Re: Turkey Point Units 3 and 4
Docket Nos. 50-250 and 50-251
Response to Request for Additional Information for the
Review of the Turkey Point Units 3 and 4
License Renewal Application

ATTACHMENT 1
RESPONSE TO REQUEST FOR ADDITIONAL INFORMATION
DATED FEBRUARY 2, 2001 FOR THE REVIEW OF THE
TURKEY POINT UNITS 3 AND 4,
LICENSE RENEWAL APPLICATION

SECTION 3.2 **REACTOR COOLANT SYSTEMS**

FIGURE 1. Effect of Fluence and Oxygen Level on the IASCC Susceptibility of 304 S.S. (Reference 1)

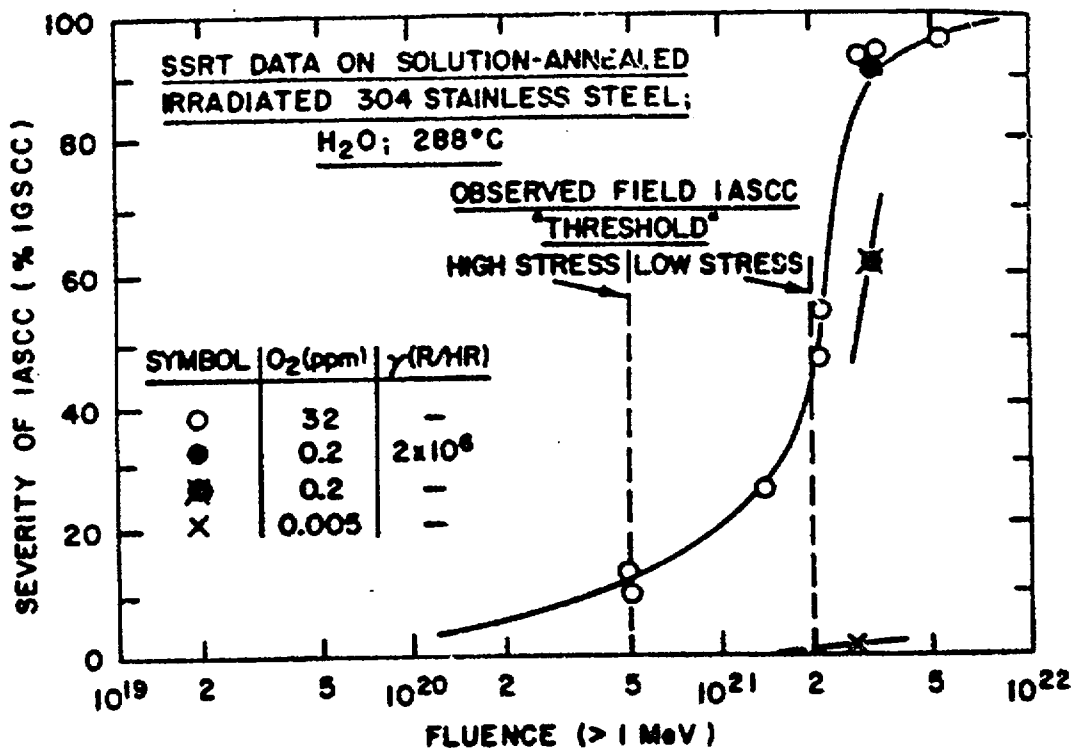
In Subsection 3.2.5.2.1, FPL indicates that; susceptibility has been observed at fluences as low as 1×10^{21} n/cm² in laboratory studies on Type 304 stainless steel in PWR environments, Type 316 stainless steel is less susceptible, and field information suggests that greater exposures are required for the development of susceptibility. The staff requests that FPL identify the field information that suggests that greater exposures are required for the development of susceptibility.

Figure 1 (Reference 1), shows the threshold type behavior in boiling water reactor (BWR) type environments with field data for observed cracking being at a somewhat higher threshold than laboratory data. The figure also shows that when the oxygen level is reduced to very low levels, closer to PWR conditions, the threshold for the laboratory observation of IASCC moves to greater than 10^{21} n/cm².

FIGURE 4. Fracture Toughness Behavior as a Function of Neutron Dose (Reference 10)

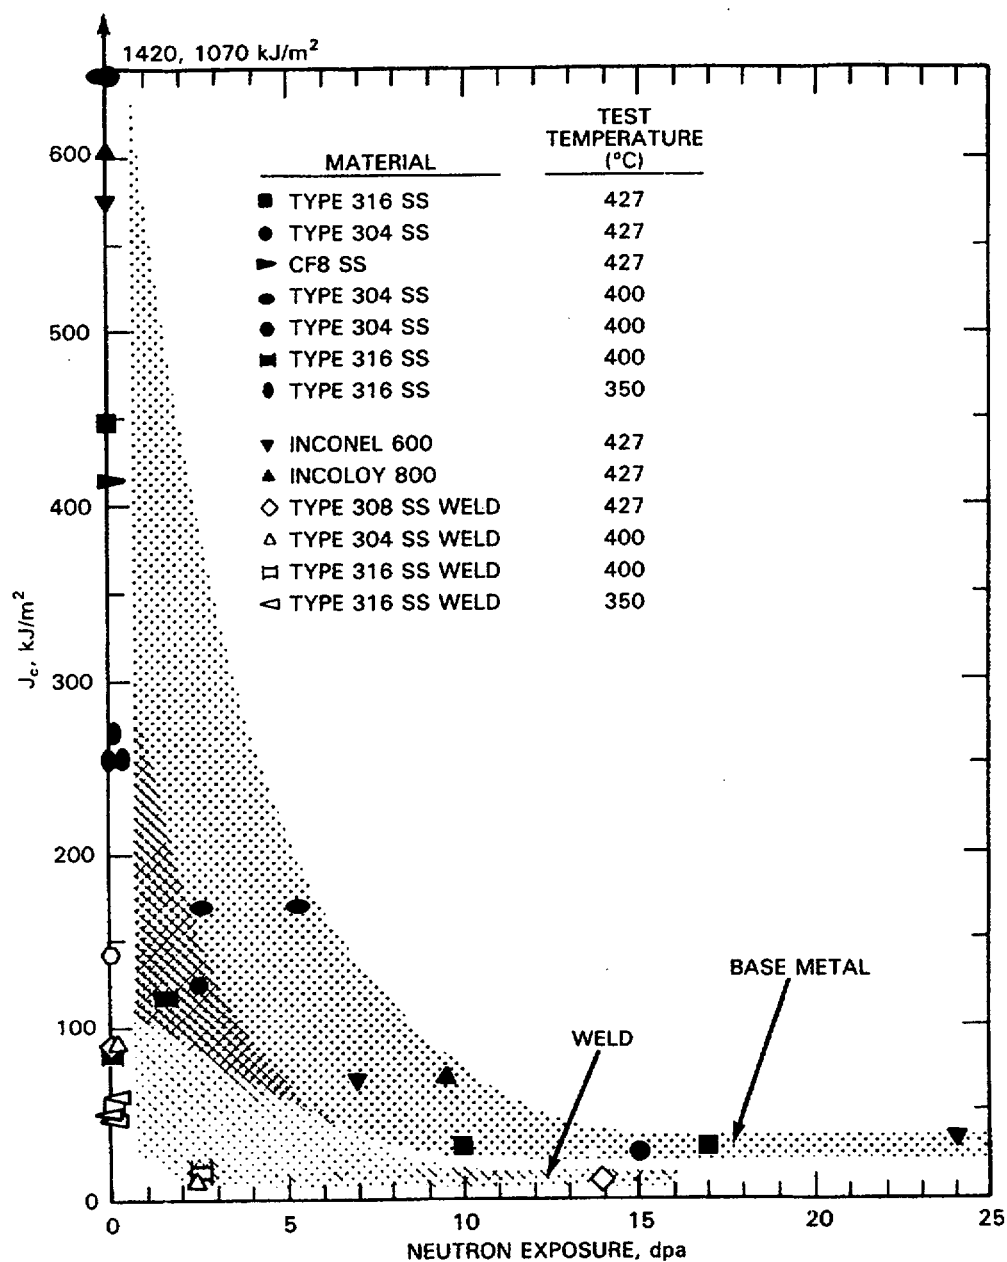
The application uses 1×10^{21} n/cm² ($E > 0.1$ MeV) as a fluence threshold for neutron embrittlement of stainless steel used to fabricate internal components. Provide data to support this position, or revise the application to expand the list of potentially susceptible components to include those at lower fluences.

There appears to be a similar reduction in toughness at fluences in the region of 10^{21} n/cm² for cast austenitic stainless steels, such as CF-8 and CF-8M, and for welds such as 308 and 309. The data for many welds irradiated at intermediate temperatures (370°C to 430°C), even those with high molybdenum, show that "exposures up to 1 dpa have no significant effect on fracture resistance (Reference 7)." The literature data on castings is limited (Reference 10). That which is available indicates that the fracture toughness of an SA351 CF8 casting with 15% delta ferrite behaves in a similar manner to a 308 stainless steel weldment with 7% delta ferrite when irradiated (Reference 10). The data is less than that observed for the wrought material (see Table 1) suggesting that the saturation value is less, probably due to the ferrite in the structure. The austenitic phase will continue to fail in a ductile manner, as shown previously. The threshold before signs of embrittlement are observed appears to be similar to that for the wrought austenitic materials, see Figure 4.
